Contract Program or Project Title: **Technical Update of Reactor Pressure Vessel Structural Integrity Program
Materials Science and Technology Division**

Subject of this Document: **Review of Draft NUREG Report on Technical Basis for Revision of Regulatory Guide 1.99**

Type of Document: **Letter Report**

Date of Document: **March 31, 2008**

Fig. 2.1. Plots showing TTS differences between RM-9 and EONY models vs TTS (ΔT_{30}) (with base models in top plot and optimized models in bottom plots) for (a) forgings, (b) CE plates, (c) Non-CE plates, (d) standard reference materials, (e) Linde 80 welds, and (f) other than Linde 80 welds.

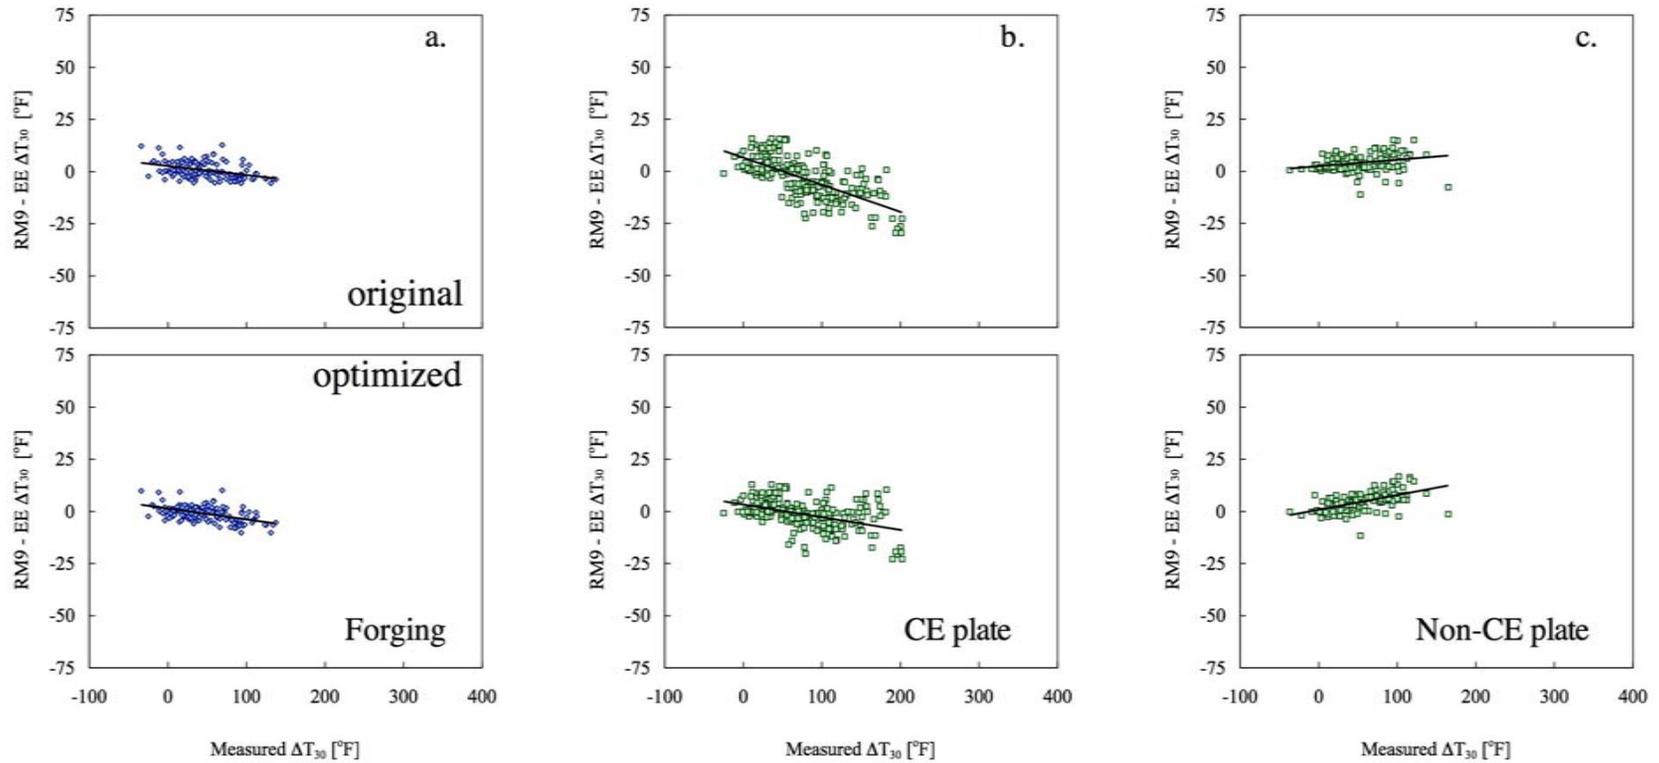
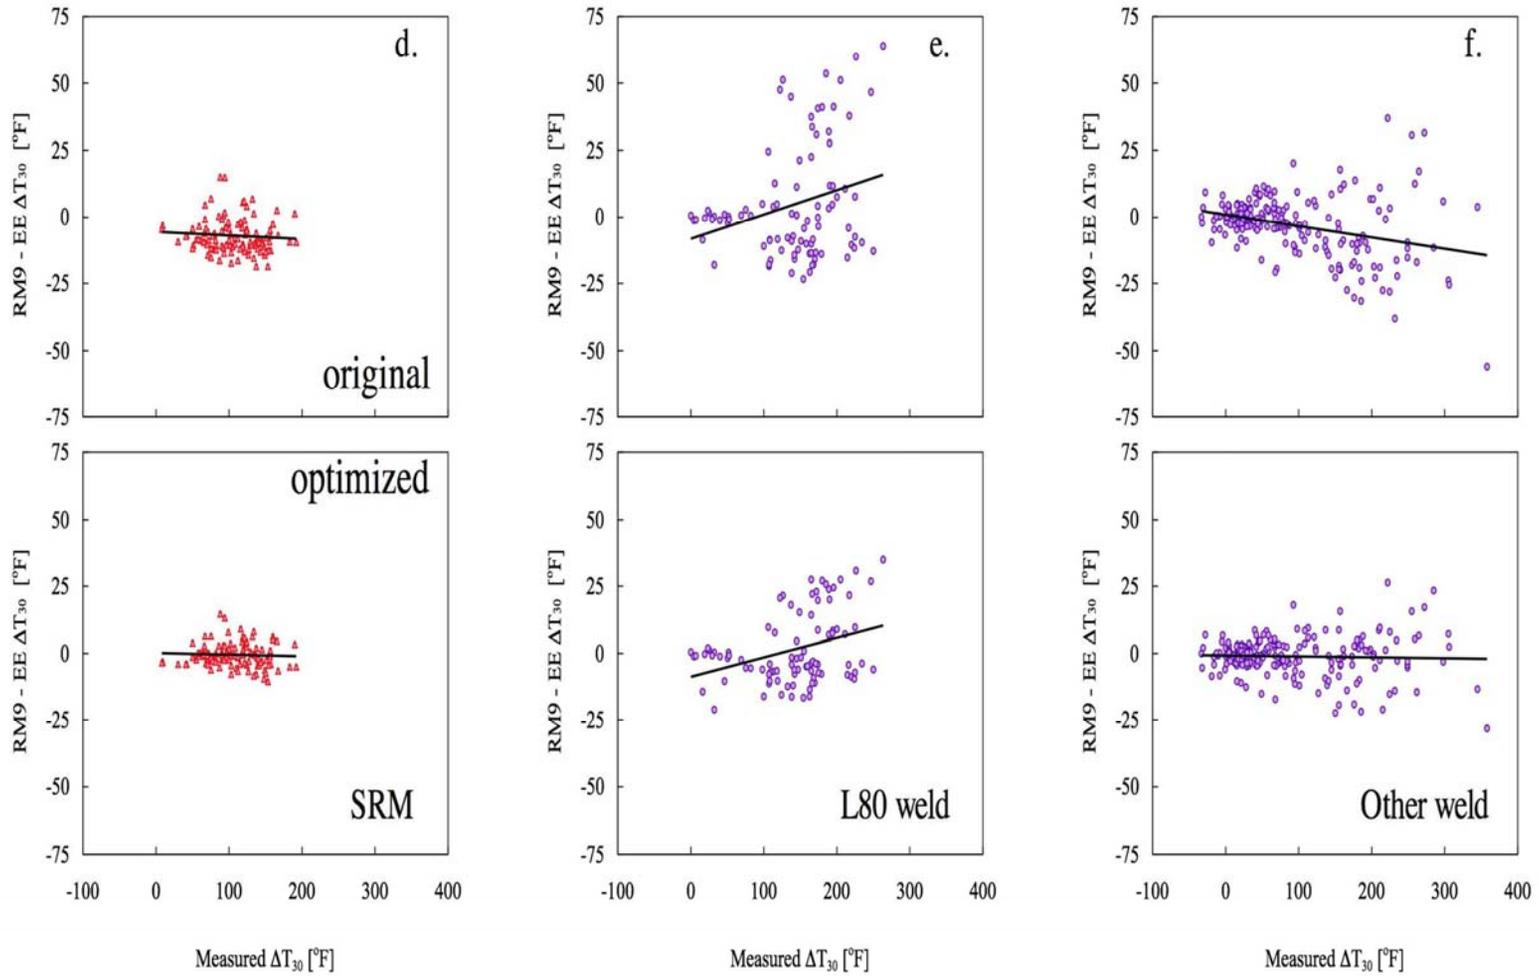
As shown in Fig. 2.1, there are differences in the predictions of the EONY and MEK models even after they have been optimized, although the differences are less than those for the base models. The differences depend on the combination of all the independent variables in the models. An extensive analysis does not suggest that one model is generally better than the other, so we have no clear recommendation as to which one to pick for possible use in RTG 1.99-3. The EONY model has slightly better statistical fit parameters and provides slightly better predictions of the highest fluence data for sensitive welds. The MEK model is in better agreement with the low-Cu IVAR data. The MEK model is also more consistent regarding flux effects and the temperature dependence of irradiation hardening found in the IVAR database. The EONY model may be slightly more conservative for Combustion Engineering (CE) plates but less conservative for high-Cu ($> 0.3\%$ Cu) welds in general and Linde 80 welds in particular. The variations in the TTS prediction reflects the major differences in the models that lie in the treatments of product forms and maximum effective Cu contents.

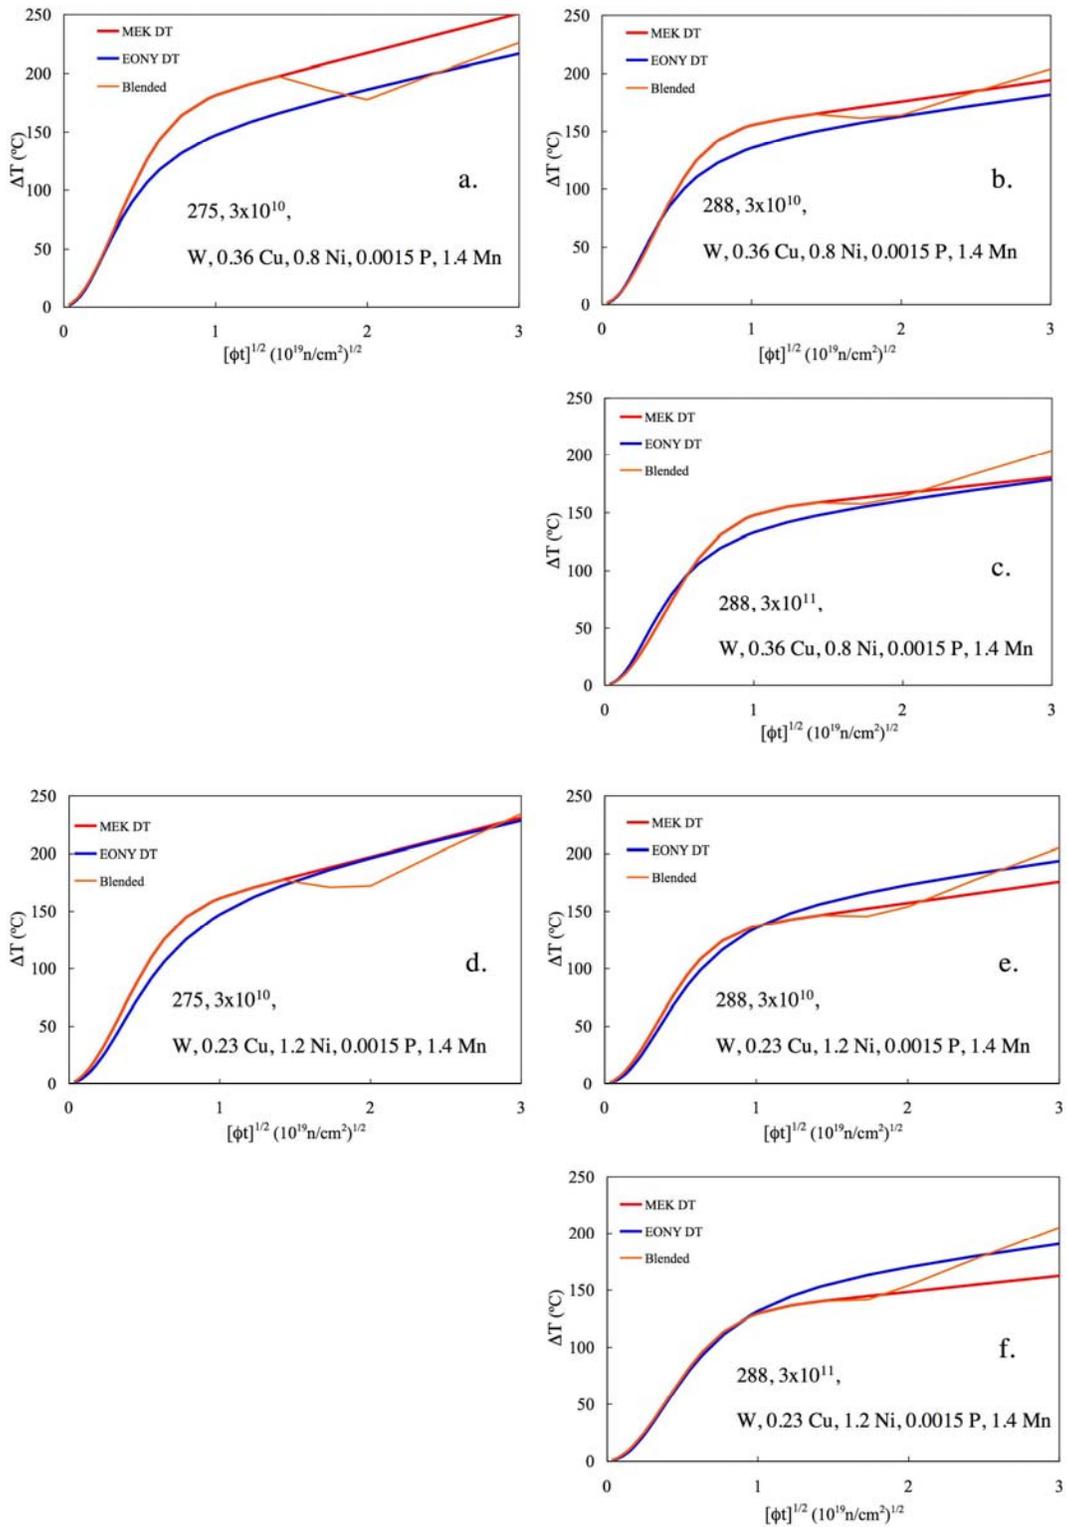
- The RADAMO model does not always work as intended. Indeed, it systematically *underpredicts* the low-flux TTS models in perhaps what are the most important embrittlement regimes associated with high-sensitivity steels irradiated at lower flux and temperature. Underprediction is illustrated in Fig. 3.11, which shows TTSs for the MEK and EONY optimized models for alloys with compositions similar to Maine Yankee (0.36 Cu, 0.8 Ni) and Palisades (0.23 Cu, 1.2 Ni) welds. Moreover, as shown in Fig. 3.11, the blended curves (i.e., RM-9 and RADAMO combined) often exhibit abrupt changes in slope (e.g., from positive to negative) with increasing fluence.

Thus, in summary, we do not find the recommendation in the draft NUREG report related to the use of the RADAMO model to be acceptable for predicting low-flux TTS.

Fig. 5.1. Attenuation of neutron fluence, $E > 0.1$ MeV and $E > 1.0$ MeV, dpa, and the exponential formula from RG 1.99-2 for typical PWR and BWR vessels.

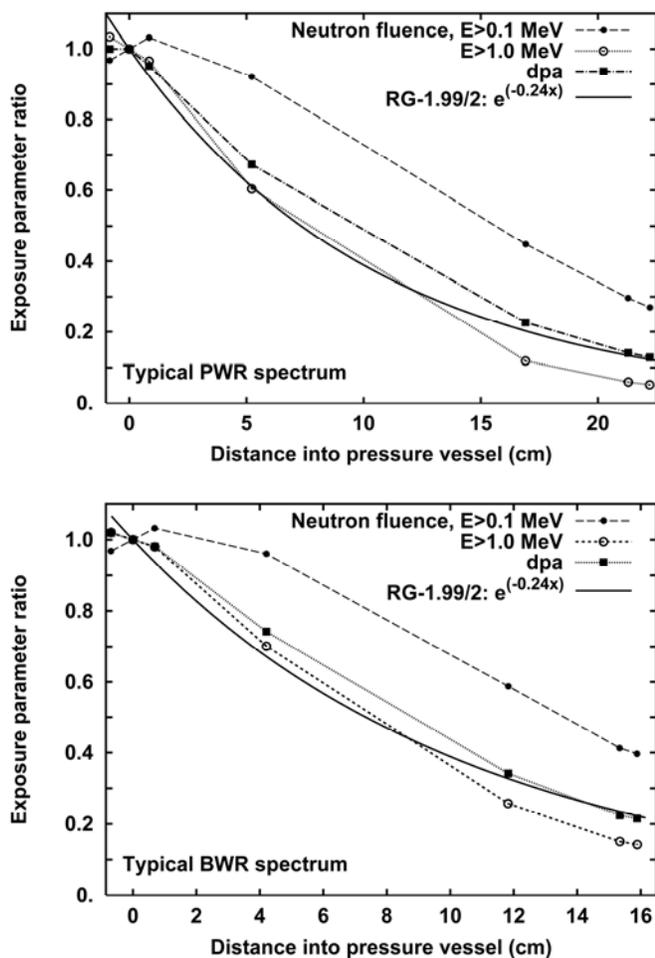
Since the differences between the calculated dpa profiles and the exponential formula shown in Fig. 5.1 are not large, an alternate procedure would be to permit the use of the exponential function in RG 1.99-2 as a substitute for the dpa ratio in the equations shown above. However, this will be slightly nonconservative in some cases, and it is believed that current neutronic practice in the industry already includes calculation of the required dpa values.

In summary, the current Regulatory Guide 1.99-2 procedure recommended in the draft NUREG for attenuation should not be employed. Whichever embrittlement model is used, it is important that it be applied in a self-consistent manner with respect to flux, spectral effects, and irradiation temperature when predicting embrittlement at locations within the RPV wall. The authors of this report recommend the two-step procedure enumerated earlier in this section.
